# PRODUCT CHANGE NOTIFICATION

## Bourns® Model PAD00x-T764 Series Push-Pull Isolation Transformer *Change to Case and Potted Design*

Riverside California – February 21, 2023 – In the spirit of continuous improvement, effective June 4, 2023, Bourns will change the design of the transformer case and the potting of the [Model PAD00x-T764 Series Push-Pull Isolation Transformer](#).

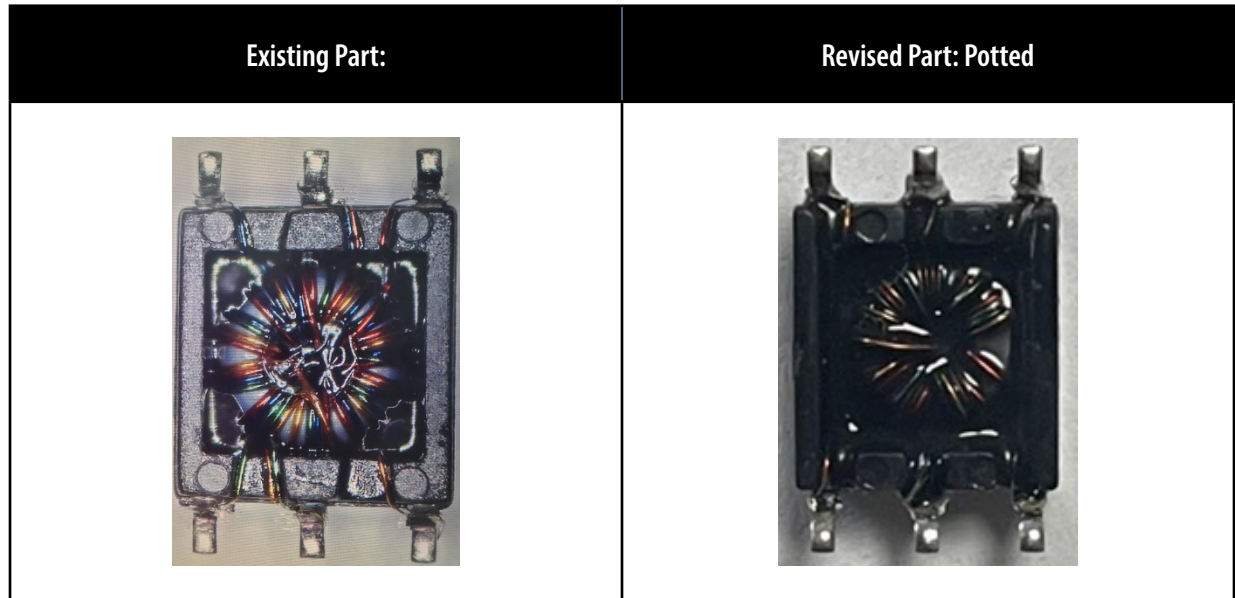
The transformer case will be changed from two lead slots to three lead slots. This will reduce the length of the tin wire and the risk of short circuit between the windings. The change to the case is shown below:
